IEEE 802.16 Broadband Wireless Access Working Group <http: 16="" ieee802.org=""></http:>
Title	On the use of postamble for the relay link
Date Submitted	2007-01- <u>1</u> 0 8
Source(s)	Changyoon Oh, Youngbin Chang, Voice: +82-31-279-7529 Mihyun Lee, HyoungKyu Lim, Fax: +82-31-279-5130 Jaeweon Cho, Panyuh Joo mail to: changyoon.oh@samsung.com Samsung Electronics 416, Maetan-3dong, Youngtong-gu, Suwon-si, Gyeonggi-do, Korea
	Rakesh Taorirakesh.taori@samsung.comSamsungAdvancedInstituteofTechnology
	Dorin Vioreldviorel@fmci.fujitsu.comFujitsu Microelectronics Canada IncMike HartFujitsu Laboratories Europe
	Jerry Sydir Intel Corporation
Re:	Response to call for technical contributions on 80216j-06_027,"Call for Technical Proposals regarding IEEE Project P802.16j", Sep.15,2006
Abstract	This contribution proposes the use of postamble for the relay link.
Purpose	Propose the text regarding the location of amble for the relay link in the multi-hop frame structure.

On the use of postamble for relay link

Changyoon Oh, Youngbin Chang, Mihyun Lee, HyoungKyu Lim, Jaeweon Cho, Panyuh Joo Samsung Electronics Rakesh Taori Samsung Advanced Institute of Technology

Figure xx Example of minimum configuration for an in-band non-transparent frame structure

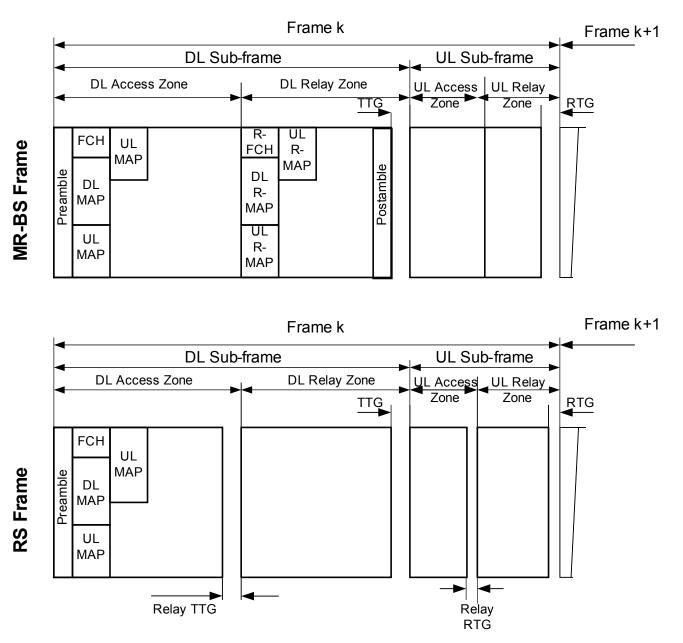
[Replace the Figure xx at subclause 8.4.4.7.2.1:]

The relay link amble, when present, shall be located at the end of the <u>last DL</u> relay zone in which MR-BS/RS is in trans-mit mode.
